MILITARY SPECIFICATION

SEMICONDUCTOR DEVICE, SILICON,  
VOLTAGE REFERENCE (TEMPERATURE-STABLE)  
TYPE 1N430A, 1N430B

This amendment forms a part of Military Specification MIL-S-19500/335(EL) 1/, 28 June 1965, and is approved by the US Army Electronics Research and Development Command, Department of the Army, and is available for use by all Departments and Agencies of the Department of Defense.

MIL-S-19500/335(ER)  
AMENDMENT 2

FIGURE 1. Physical dimensions.

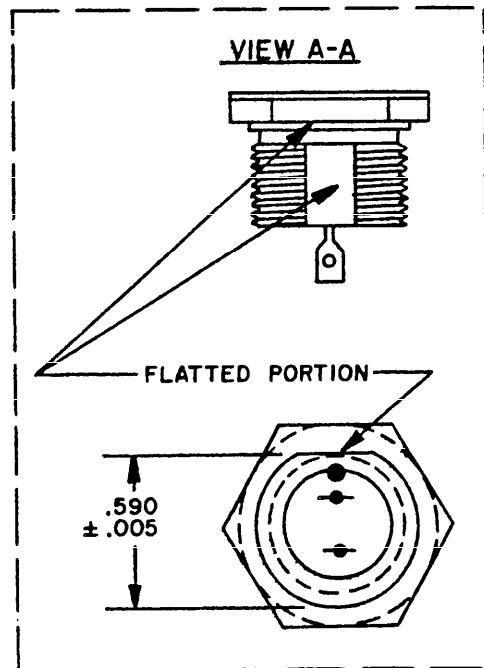
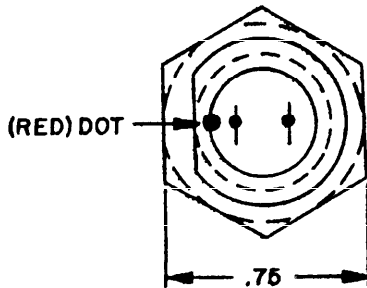
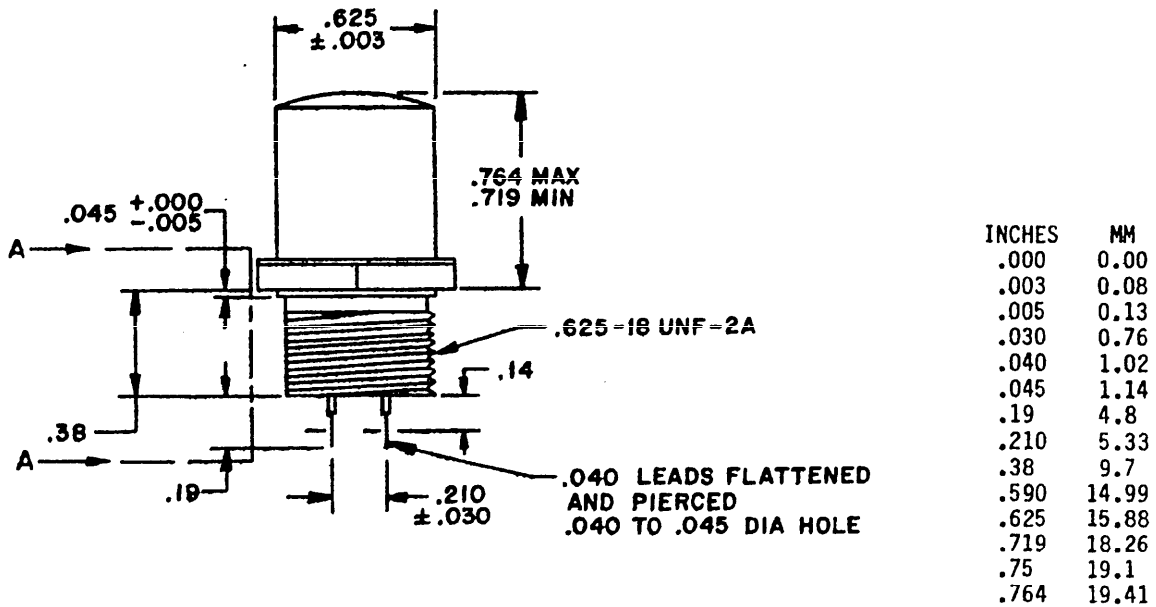
Figure 1, delete and substitute new figure 1 as printed on page 2 of this amendment.
